Our reference: R/2021/10/A

Your reference: SSD 32927319

Subject: Advice on EIS - Powerhouse Ultimo Renewal - Stage 1 - SSD 32927319

REF-DA-TEST I02-discrepancy between the 3D CAD model and submitted arch dwg North west elevation-Dwg no.AR0700-revision 8

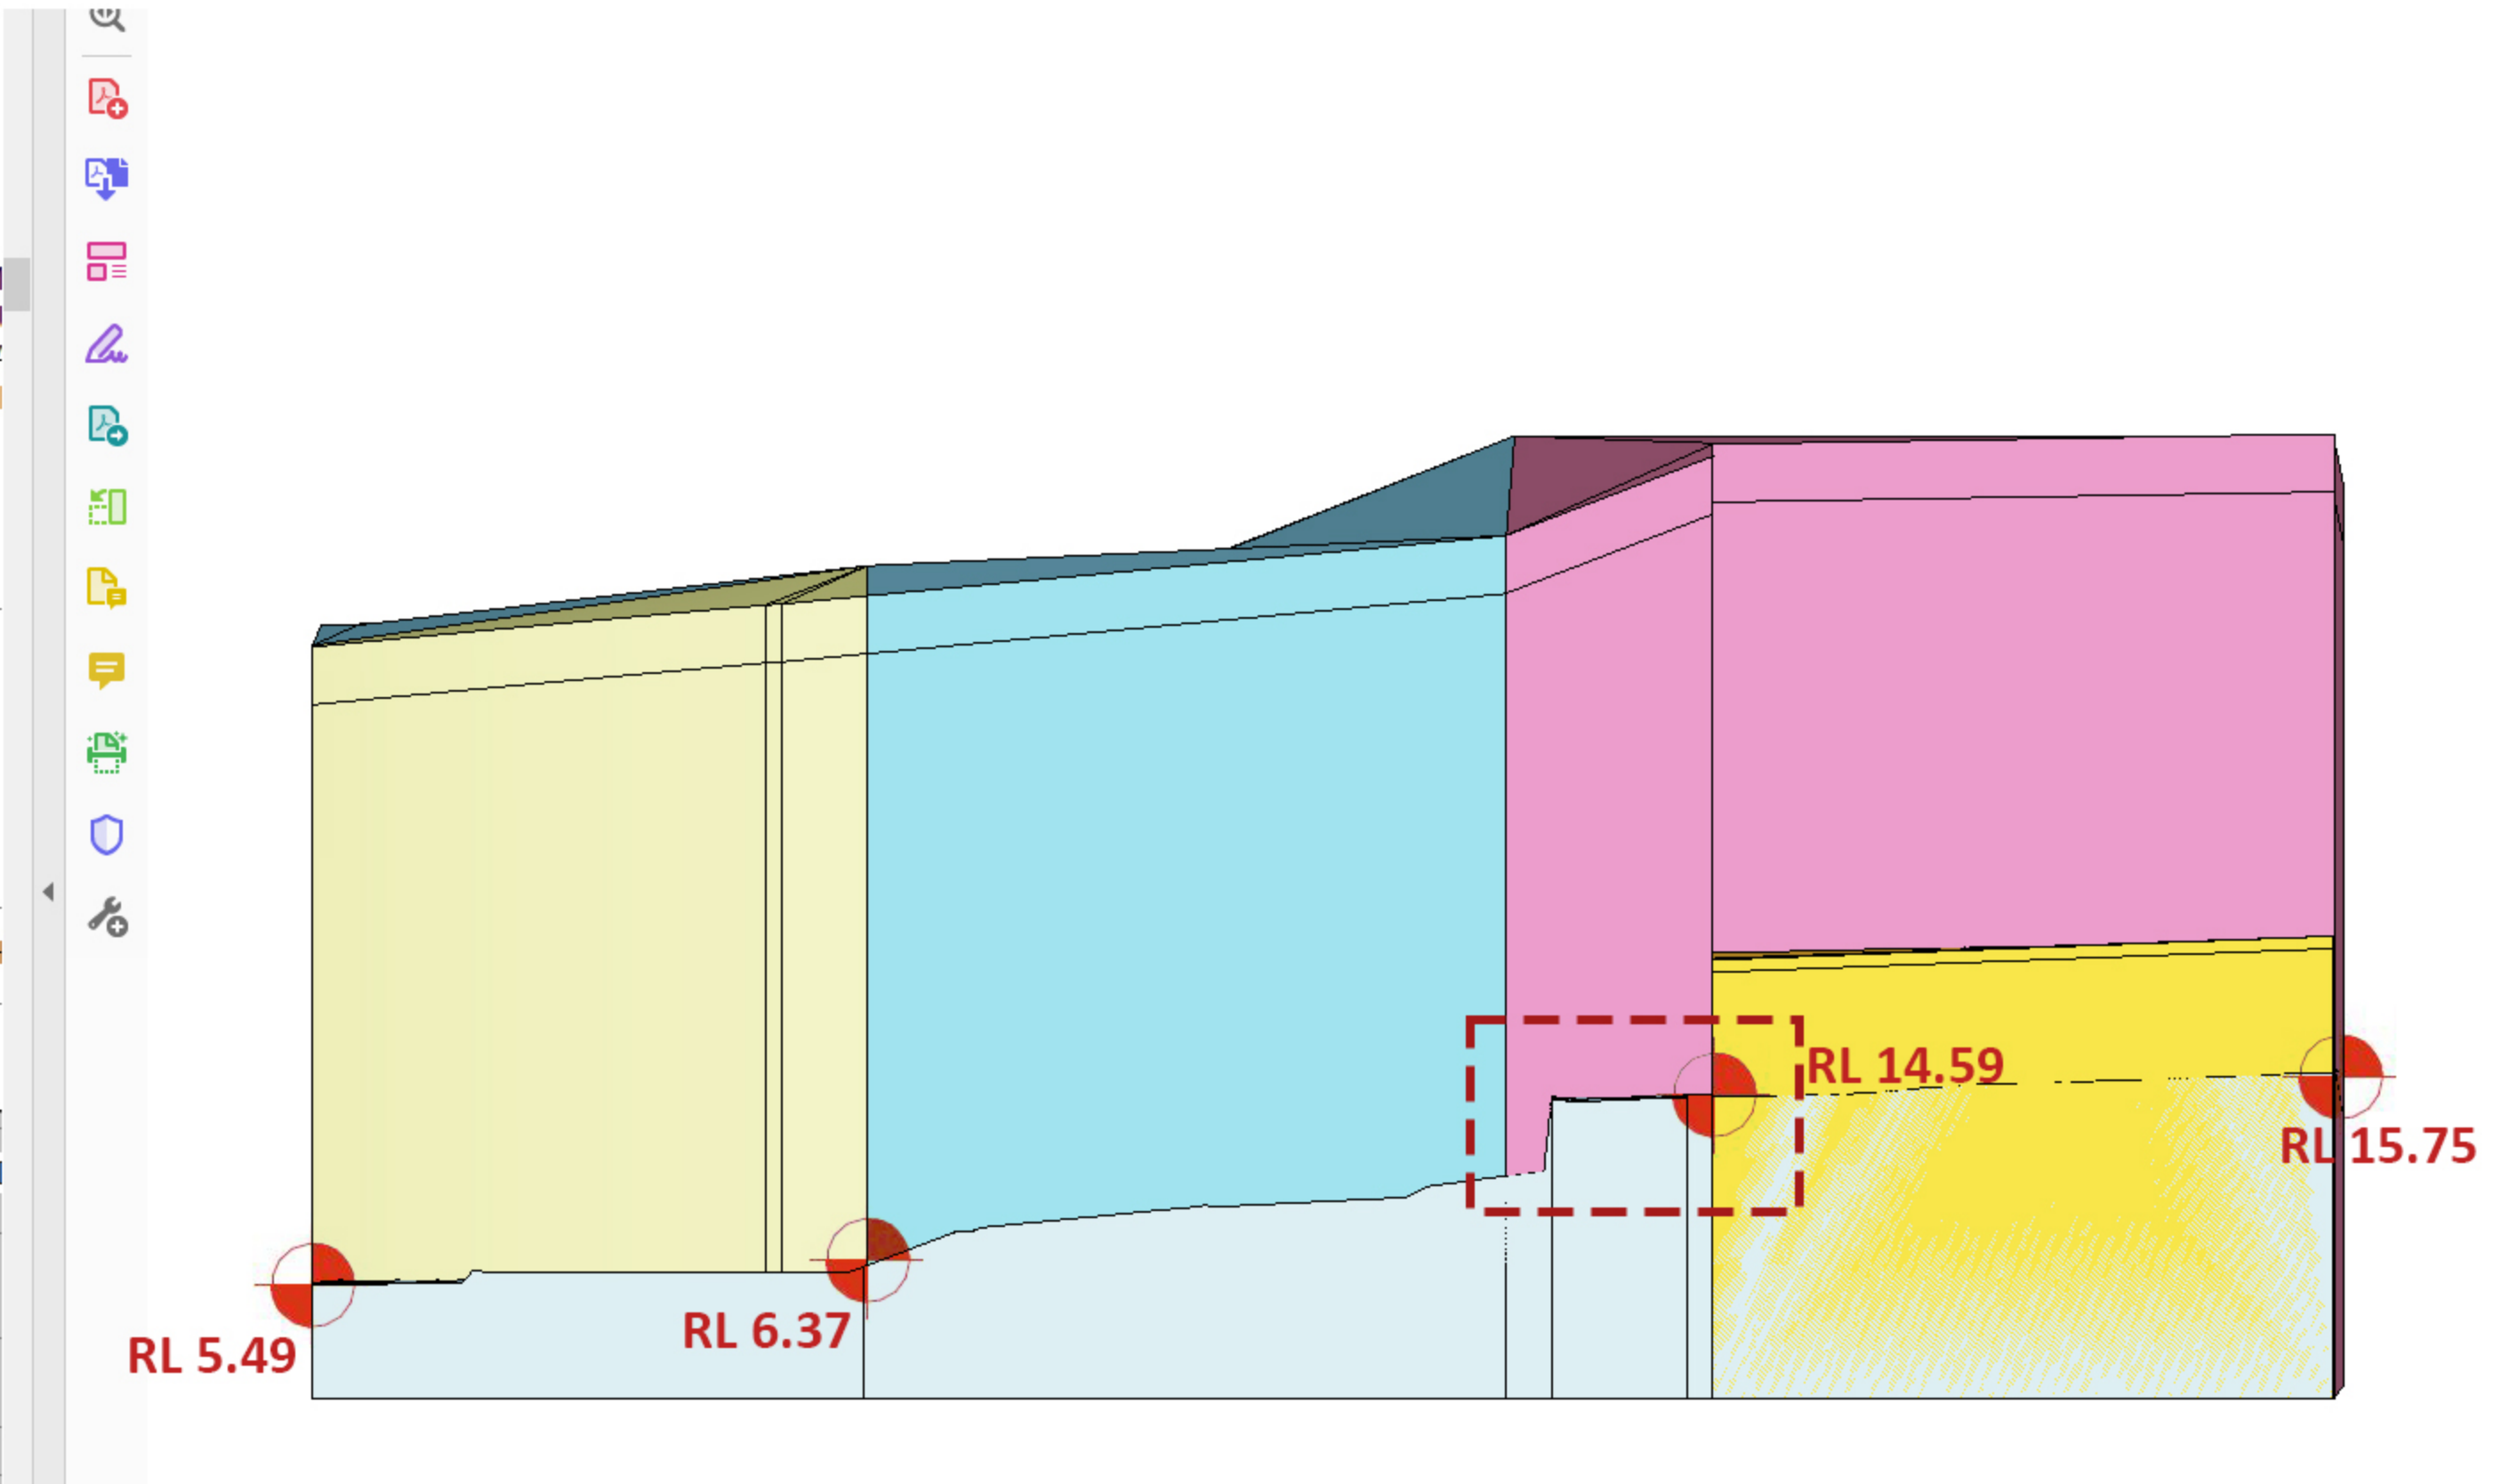
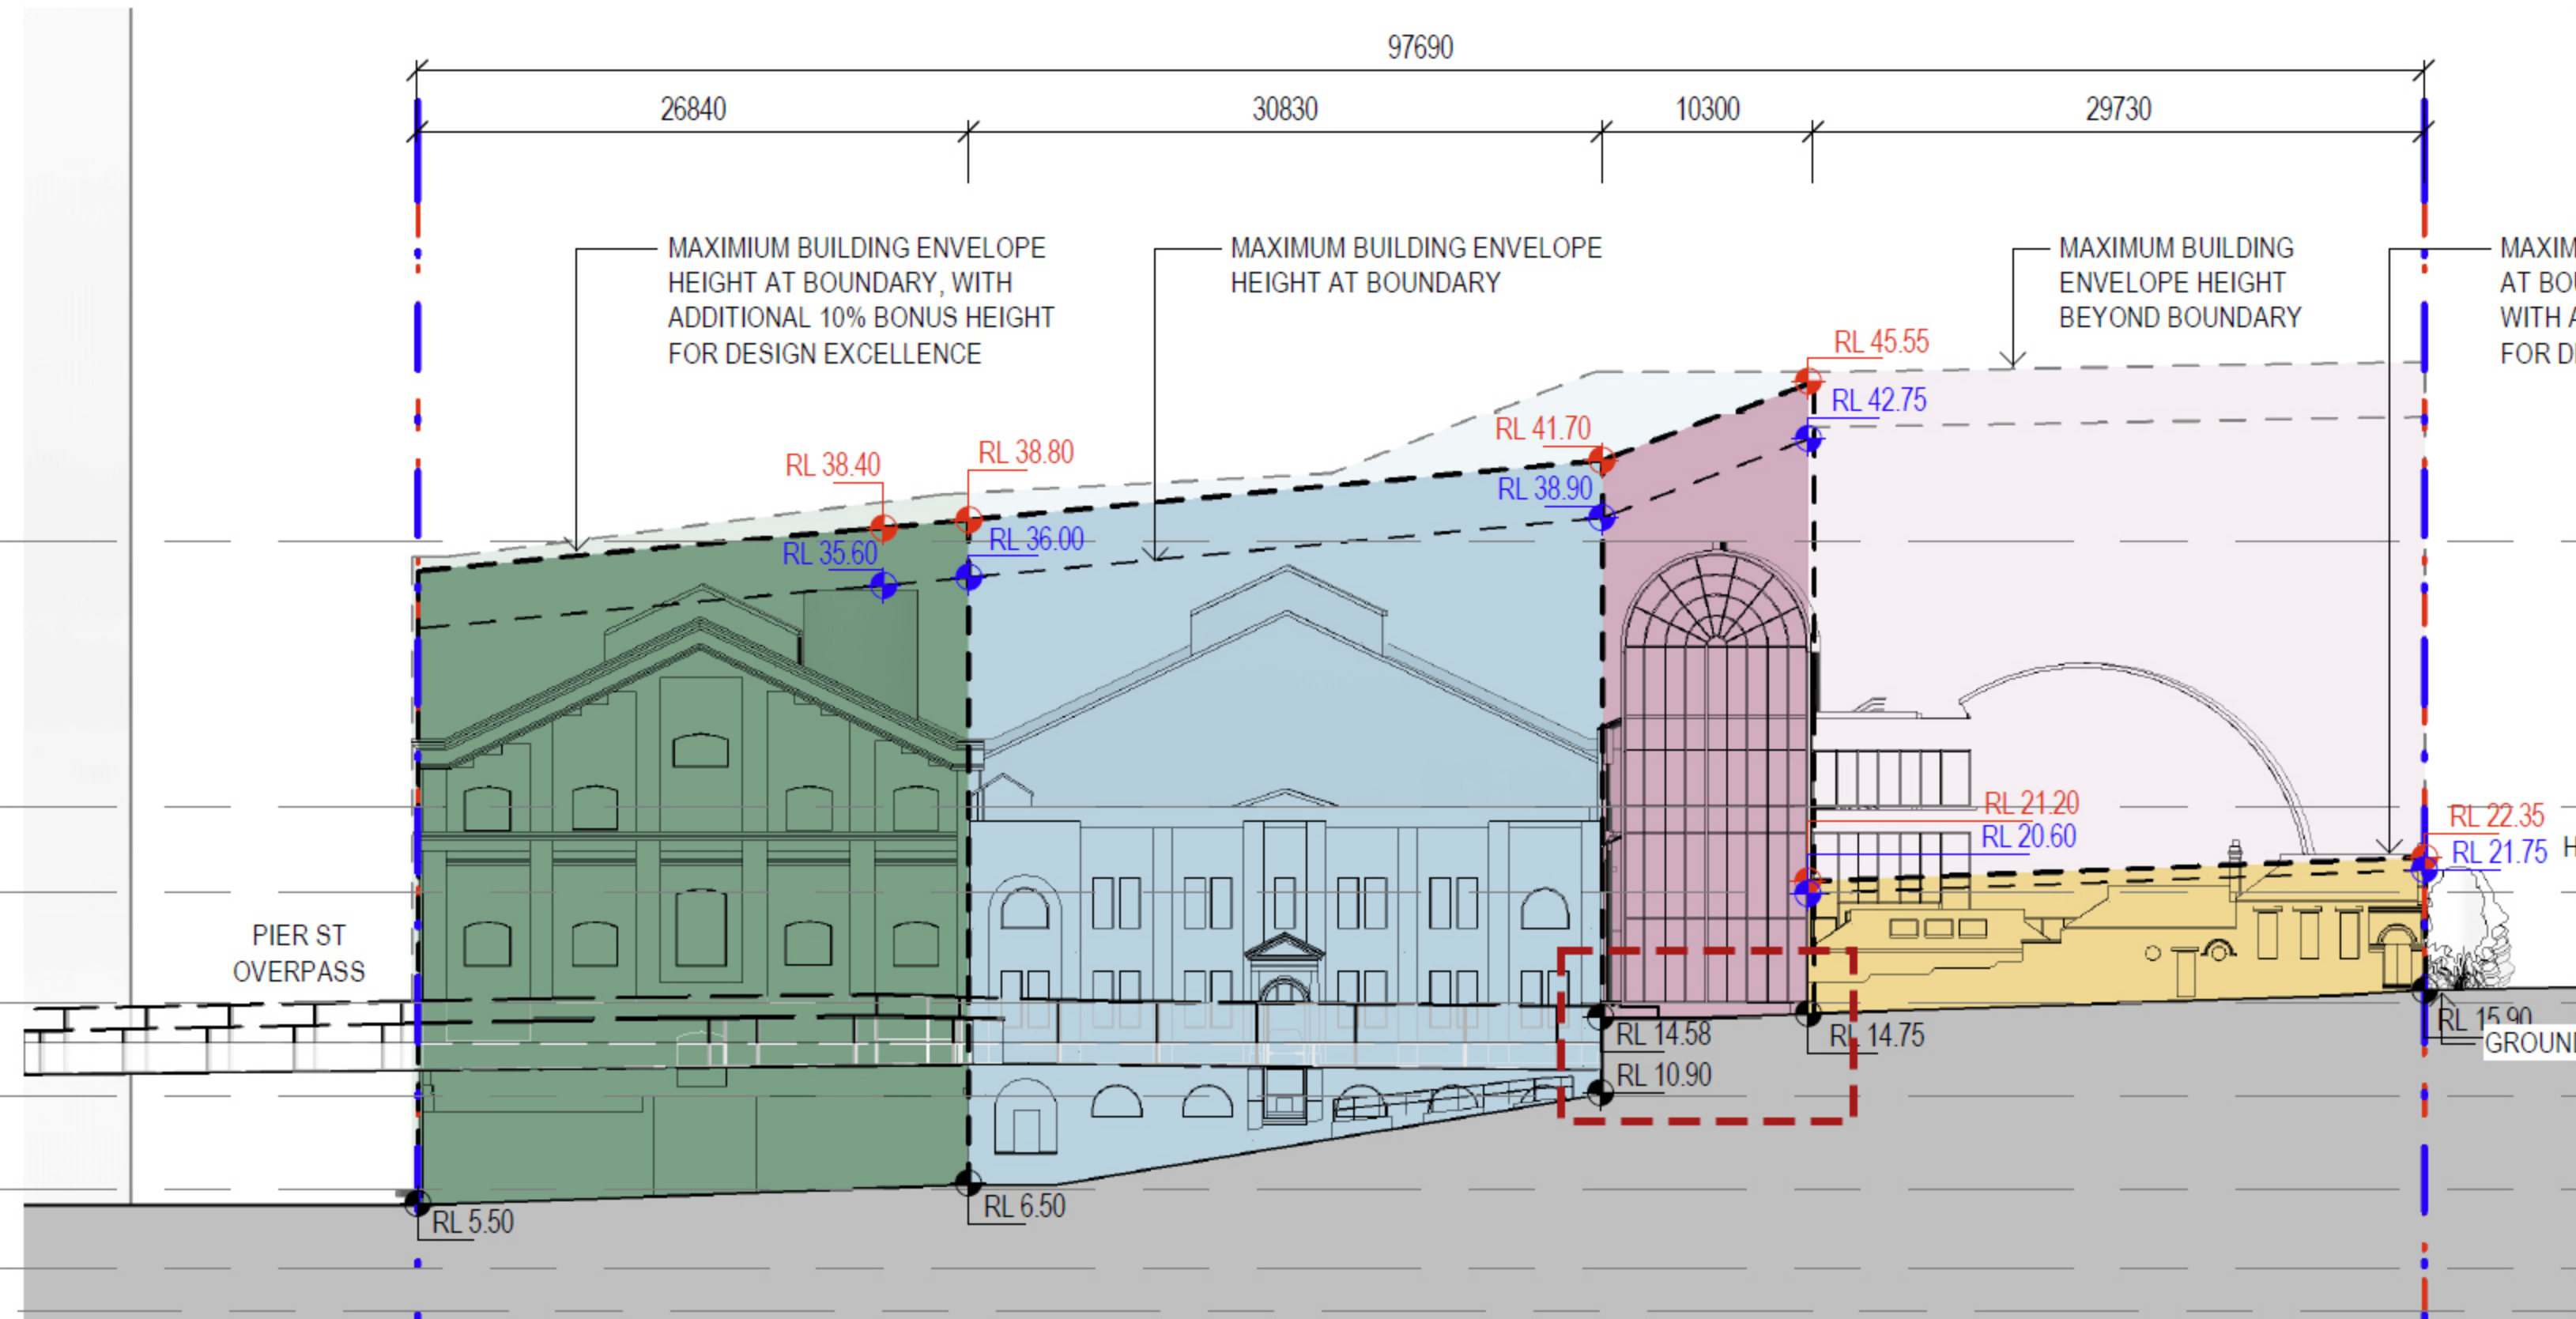
Ground terrain geometry and RL differs to submitted drawings

REF-DA-TEST I03-discrepancy between the 3D CAD model and submitted arch dwg -South west elevation-Dwg no.AR0701-revision 8

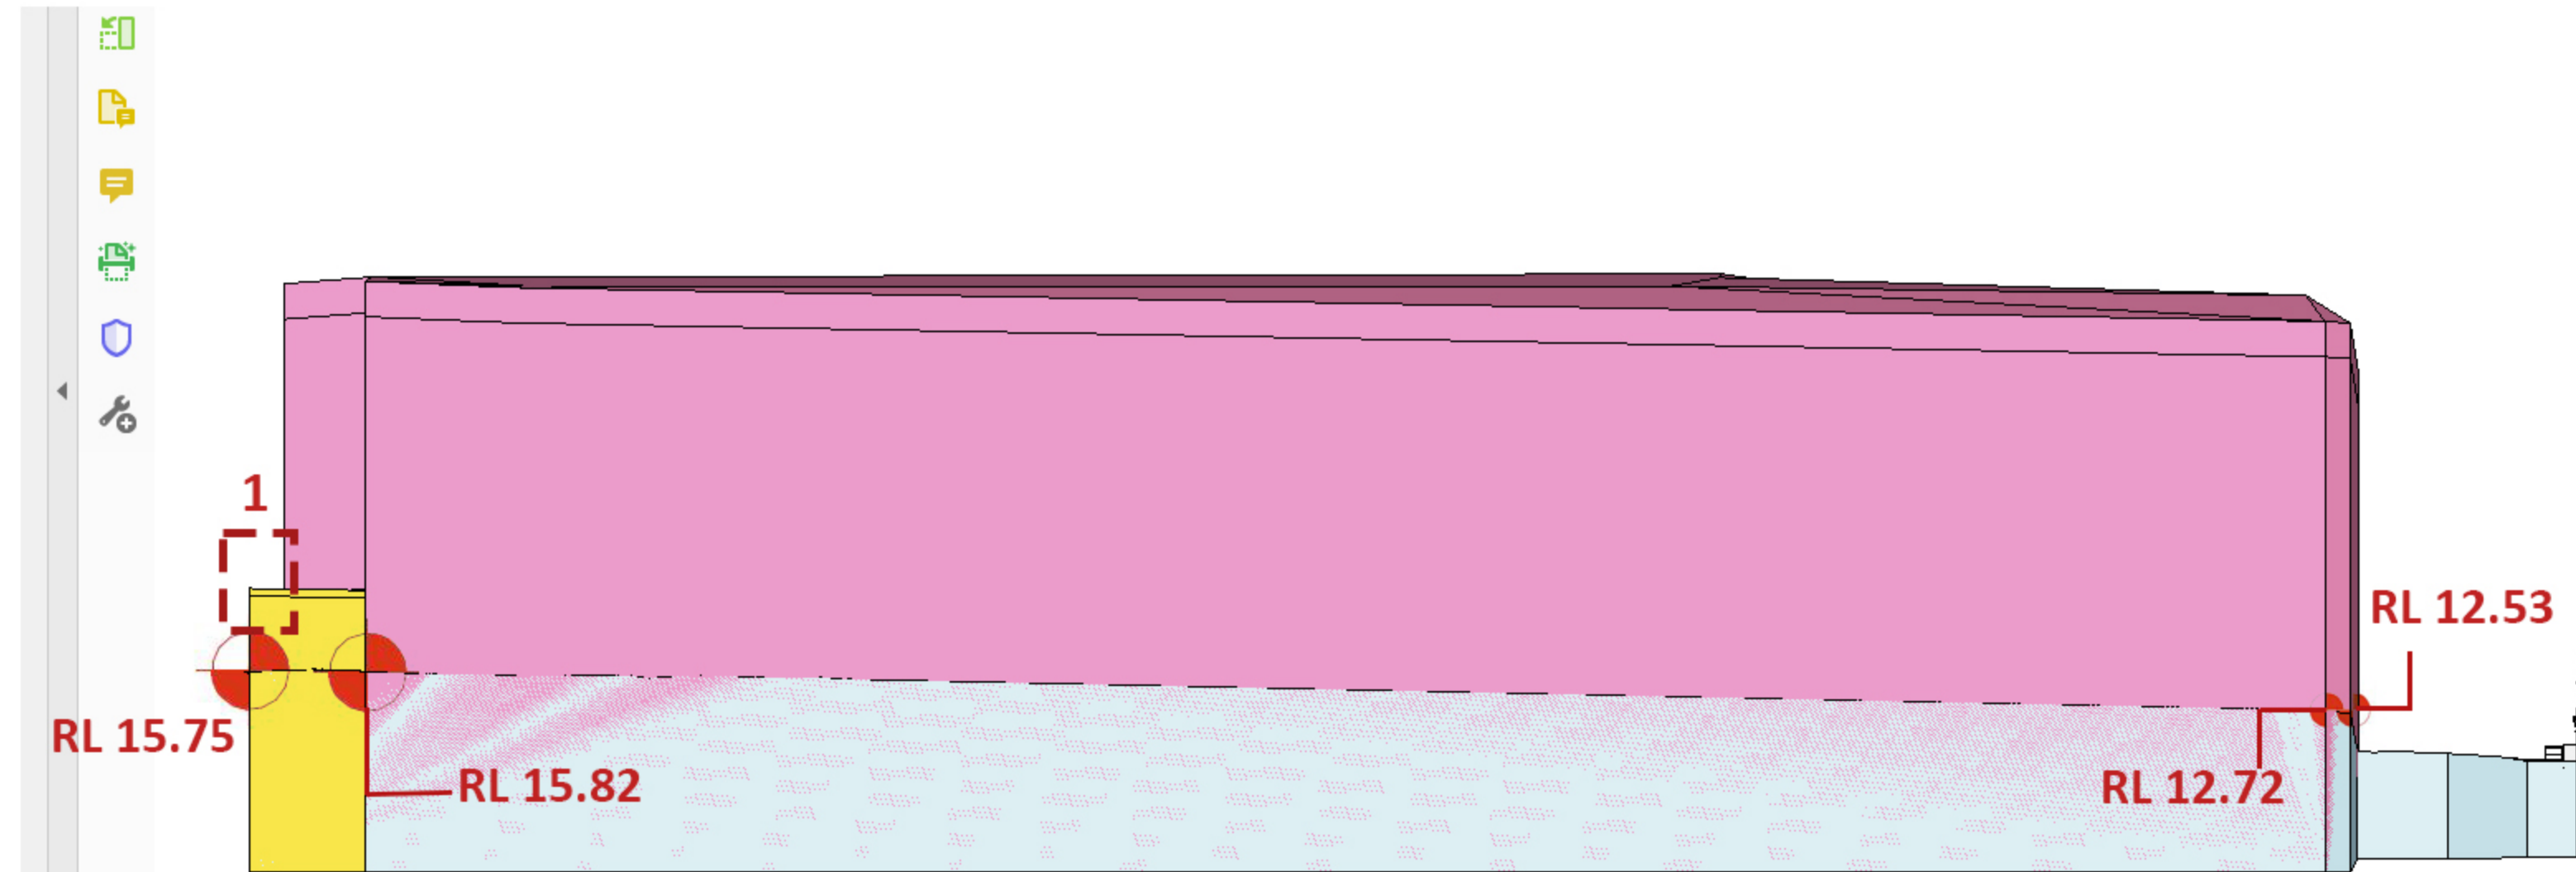
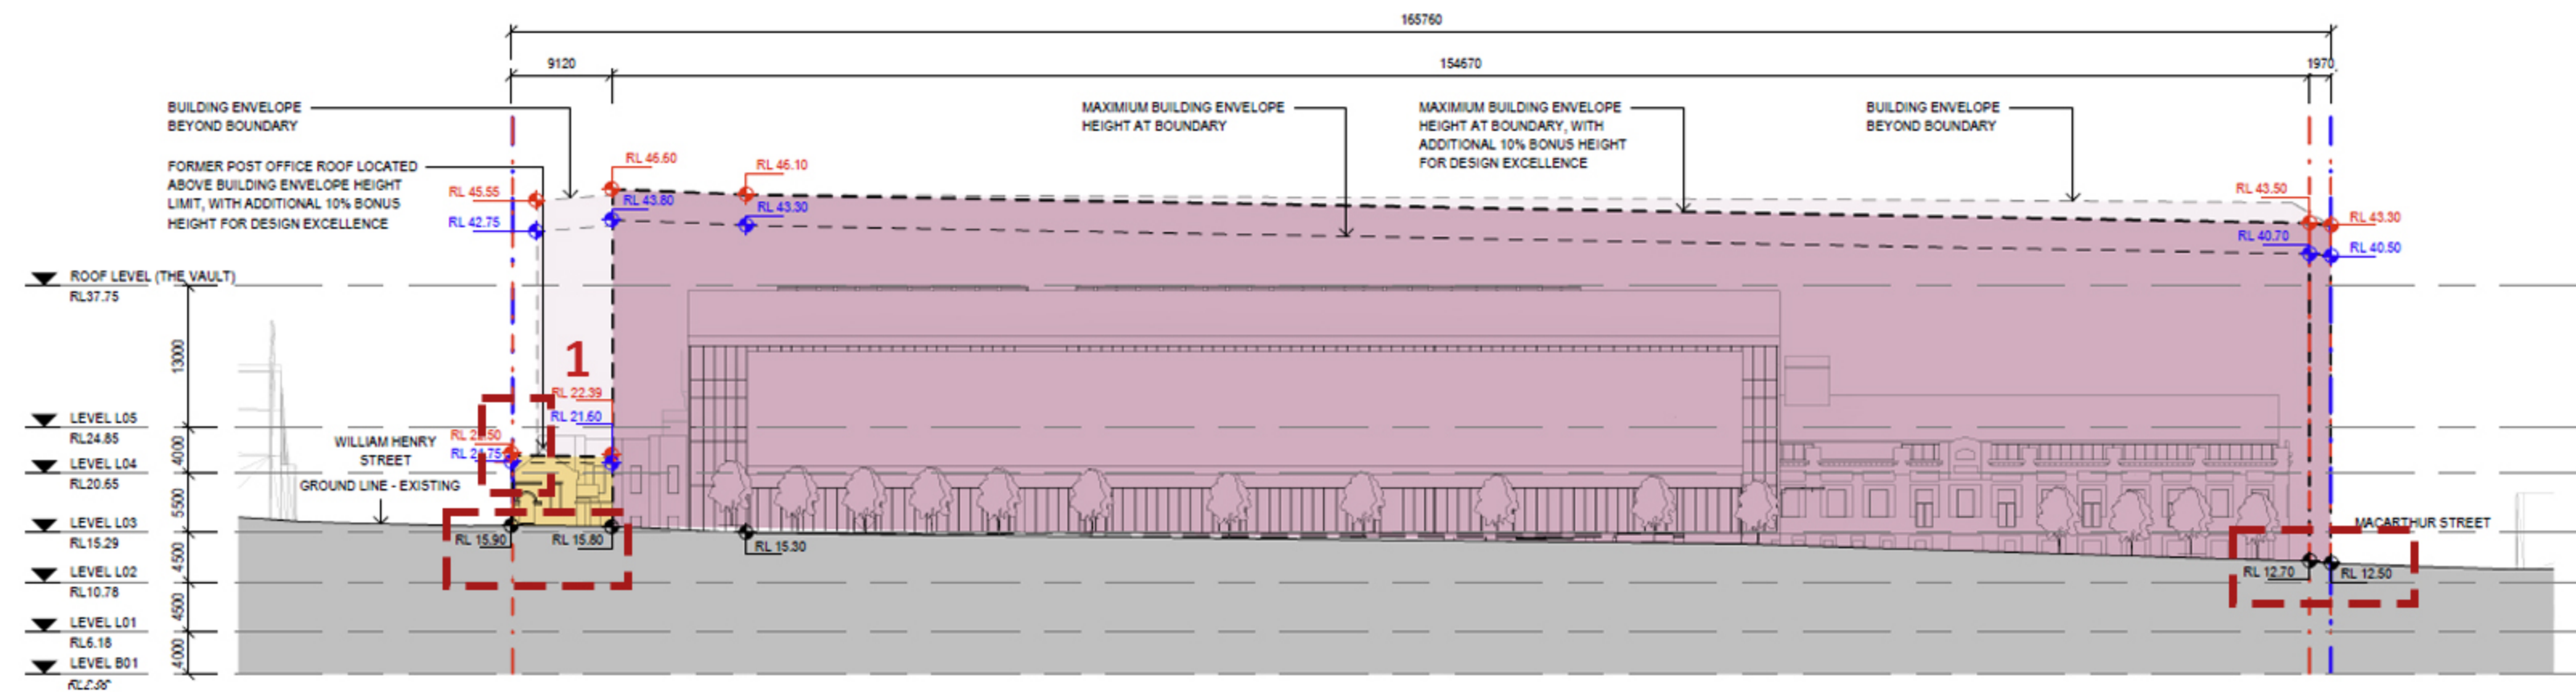
Ground terrain RL differs to submitted drawings

1-Envelope height with 10% bonus on the same point differs on drawings- on south west elevation marked as 22.50 and on north west elevation marked as 22.35.
